# DESIGN REVIEW BOARD

DRB2014-7

Design review for the  
construction of a 24-unit  
apartment complex.

## SKYLINE HEIGHTS APARTMENTS 1420-1424 36TH AVENUE NORTHEAST

SITE PLAN -- OPTION 2

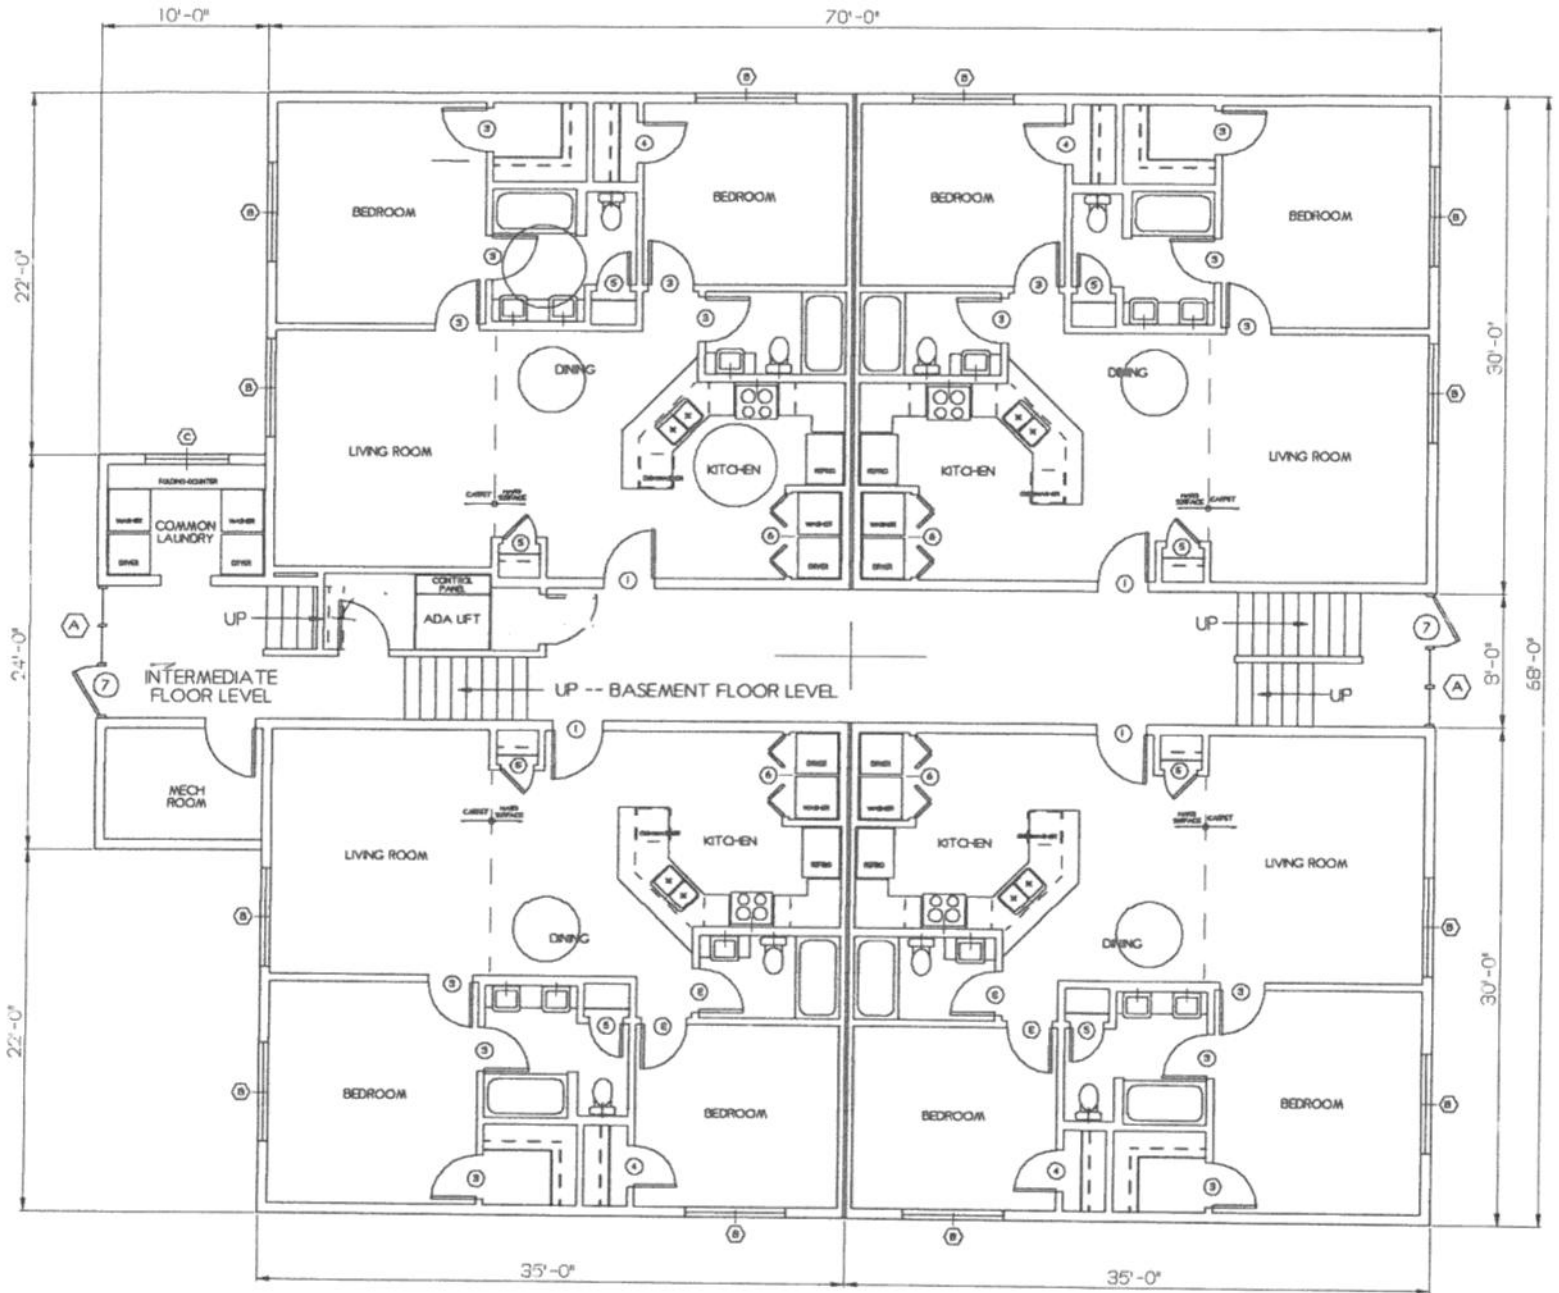
The proposed parking lot along 36th Ave NE provides 16 - 90-degree parking stalls, including two handicap van accessible spaces with access aisle and eight stalls along the front of the apartments. Phase 2 of the project shall provide the approach to 14th St NE and 24 parking stalls. The applicant will install a 15' landscape buffer and 6' screening fence between the south facing parking stalls and the single-family residence located in Water Tower Park Addition.

The proposed development of the previously unincorporated enclave is strongly encouraged and promoted as an important element of the City Growth Policy. Contrary to review guidelines, the façade of the building is not located close to the front lot line. However, the applicant feels the proposed location would better facilitate visual interest, appeal, public safety, and function. Overall, the design positively addresses access, natural terrain, and relationship to surrounding land uses and the residential neighborhoods south and west of the site. The proposed exterior material, primary entry, and façade design creates visual interest and appeal. The electrical service equipment will be located on the rear of the building. Air conditioning units for the apartments are provided by through-the-wall P-Tak on the north and south elevations of the buildings. The complex trash enclosure will be placed on the east boundary of the property and constructed of material matching the buildings. The proposed landscape plan includes boulevard trees, plantings in the side yards and within the detention pond. No information is provided on the lighting of the parking lot or pedestrian pathways of the building.

- A. The proposed project shall be developed consistent with the conditions in this staff report, all codes and ordinances of the City of Great Falls, the State of Montana and all other applicable regulatory agencies.
- B. If after the approval of the concept development plan as approved by this Board, the owner proposes to expand or modify the conceptual development plans, the Director of the Planning and Community Development Department shall determine in writing if such proposed change would alter the concept for one or more review criteria. If such proposed change would alter the plan, the proposal shall be resubmitted for review as a new application.
- C. Final plans shall include a lighting plan and meet the requirements of 17.40 Outdoor Lighting for illumination of pedestrian paths, primary building entrances and parking areas.
